**Airways New Zealand Petition
to
The Director of Civil Aviation
to
amend the Whenuapai CTR/D
and
nearby GAAs**

15 December 2018

Airways submit a petition to amend the Whenuapai Control Zone (WP CTR/D NZA155), NZG151 North Shore and NZG154 Whenuapai as detailed and supported by this document.

Figure 1. RNZAF proposed CTR modification.

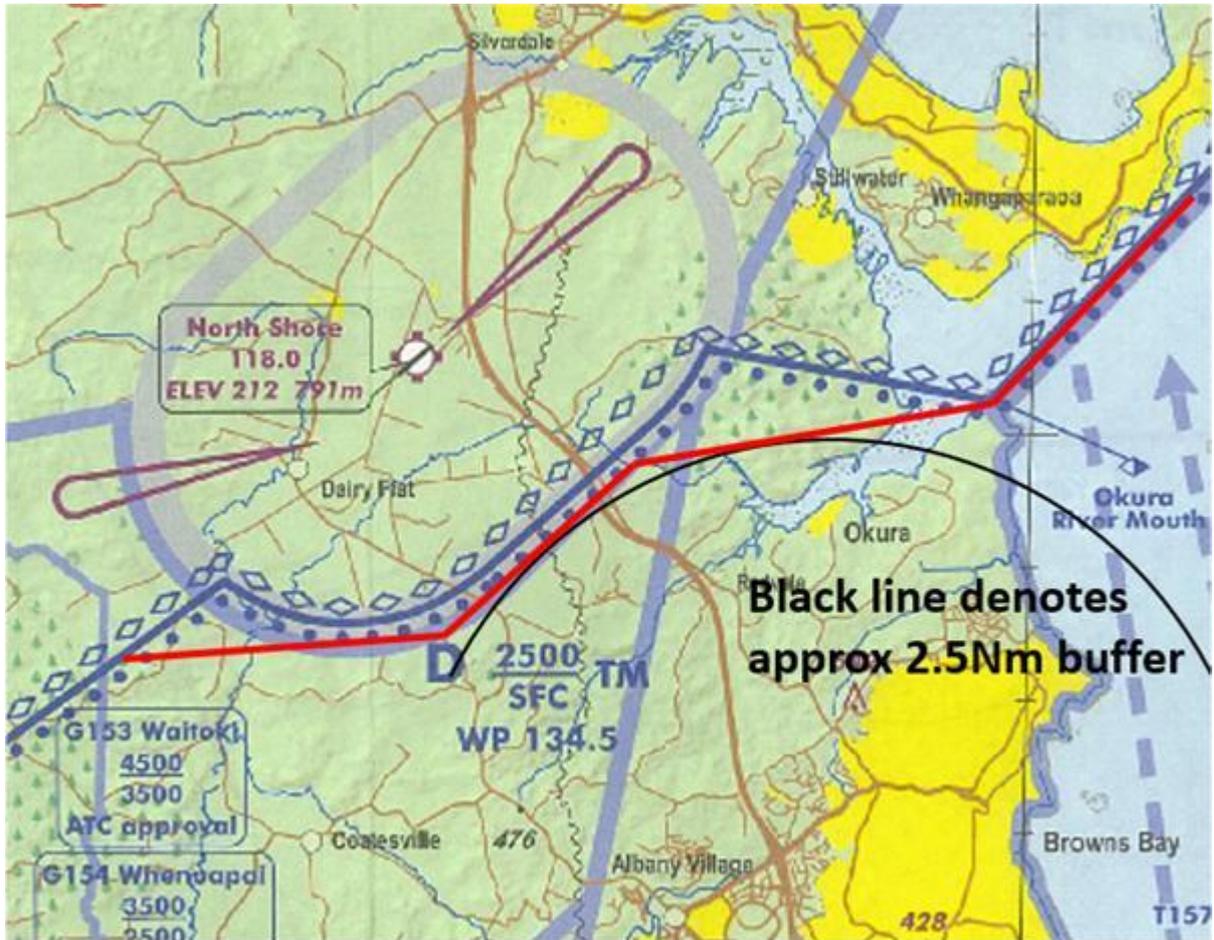
- c. The RNZAF is however open to minor boundary realignment which we believe will meet the request of the NZNE operator whilst retaining the regulatory requirements. An alternative **Modified** CTR boundary is proposed in Figure 1 below (red line); this provides operators at NZNE the ability to easily enter or vacate the local pattern without cutting airspace boundary corners whilst preserving the safety buffer applied to the current RWY 21 ILS/DME Cat A and B approach.
